Subject: Cap-less Fuel Cover
Models Years Affected: 2017 - 2019
Models Affected: Chevrolet Silverado (old body style)
GMC Sierra (old body style)
With Cap-less Fuel Fill and Gasoline Engines
Origination Date: September 4, 2019
Revision Date: N/A

ADVISORY:

Figure 1

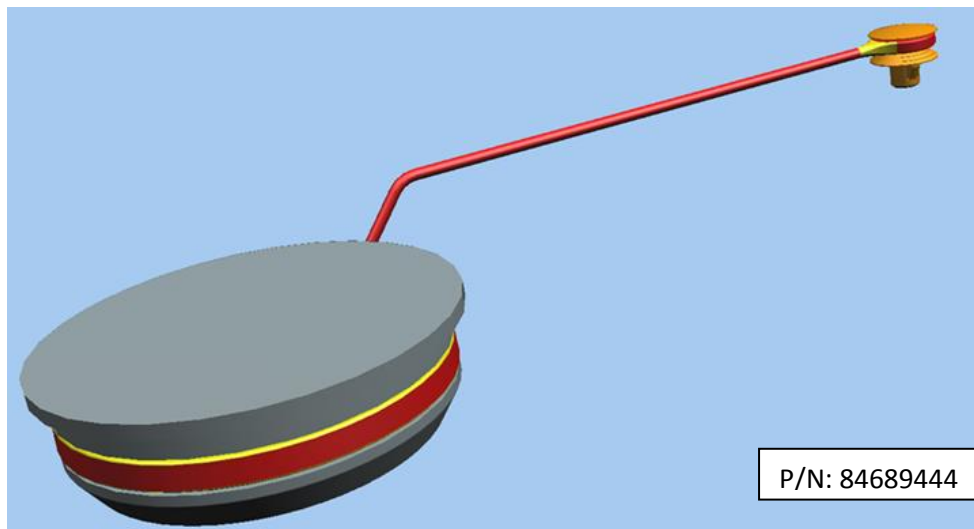
Some customer/vehicle operators may express a concern that dirt, dust and other contaminants have a potential of entering the fuel filler/tank due to contaminants making their way past the seals on the cap less unit. This issue may occur on vehicles that predominately drive on unsealed or dirt roads. This issue occurs because the fill pocket is unsealed near the hinge, and the fill pocket door is also unsealed.

Adding a tethered cap that covers the cap-less unit preventing contaminants from settling on the outer sealing door of the cap less unit. Refer to Additional Information for an illustration (Figure 1) and the part number of the tethered cap.
